Planning App Ref:	PL/2023/07503
Service Ref:	Drainage
Date:	14 April 2026

Variation of conditions 5, 6 and 7 of 15/11604/OUT - To become compliance conditions relating to the installed surface water drainage scheme and its associated maintenance regime

Westbury and District Hospital, The Butts, Westbury, Wiltshire, BA13 3EL

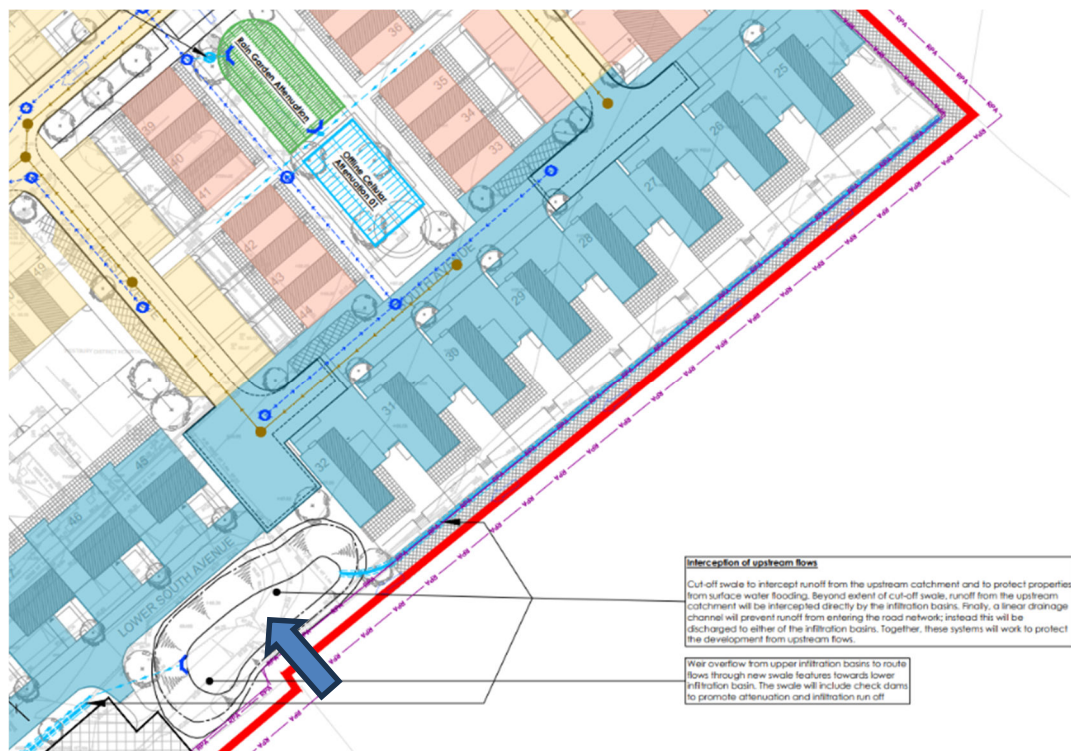
2. A video has been supplied showing that the runoff from the farmers field entering the attenuation basin in a manner which could cause the back to erode and collapse.
(Figure 2 shows the location of the runoff from the field, with this inlet photographed in Figure 3).

1. The amount of sediment that it appears to be introducing into the pond, which will reduce the operational volume available within the basin and increase maintenance burden.
2. The non controlled entry of flow into the basin, with the potential for bank erosion that could ultimately lead to over time to more sediment being carried downstream and adversely affect the stability of the embankment.

5. The applicant is to provide a formalised inflow and bank remediation works (to remediate against the clear rutting / localised erosion which is shown in both the residents and applicants photos) on the basin identified above, to be signed off by a suitably qualified geotechnical engineer, from the swale into the pond to prevent bank erosion.
